Service Kit 753-0827

CODE: PM-273

DATE: January 21, 1998

SUBJ: Cord and switch replacement on electric lawnmower models numbers 407 and 707

Exploded view of Cord & Switch Assembly (Part No. 625-0050)

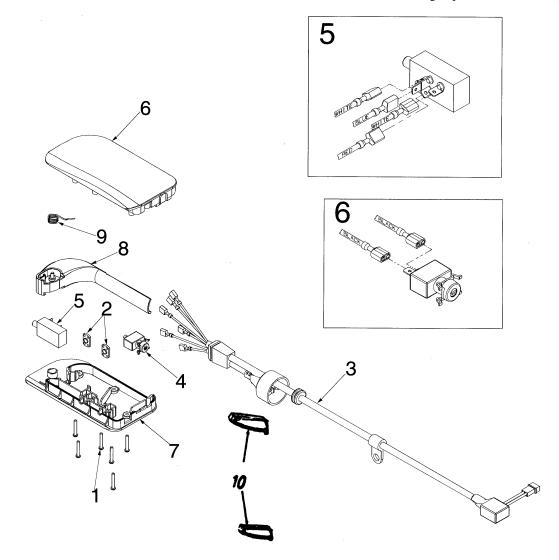
Use Service Kit number 753-0827 when replacing cord and switch assembly part number 625-0018A or 925-0018B. This kit included the updated cord and switch assembly for the current electric lawnmowers.

- 6. Remove the bail from the left side of the handle and the switch control box. Discard the bail. The bail is not use with the new cord and switch assembly.

- 7. Remove the two screws that secures the control box to the upper handle. Retain the two screws for reassembly of the new switch.
- 8. Install the new switch control box with the two screws removed in Step 7.Use two uppermost screw holes in upper handle.
